# NOTIFICATION OF MINOR CHANGE FOR THE PART NUMBER 1-002-0102-2173 STATIC INVERTER

**1.0** Aircraft Effectivity: ATR 42/72

June 22, 2016 Issue 01, Rev A SB 1-002-0102-2173-24-36

Figure 1: 1-002-0102-2173 Name Plate Label –

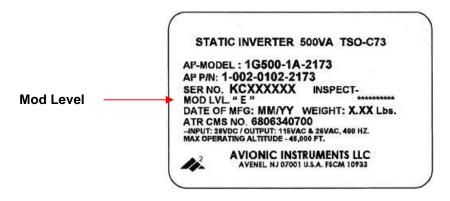
Upon completion of the modification, the label on the top panel will be changed to indicate MOD LVL. "E" (See Figure 1).
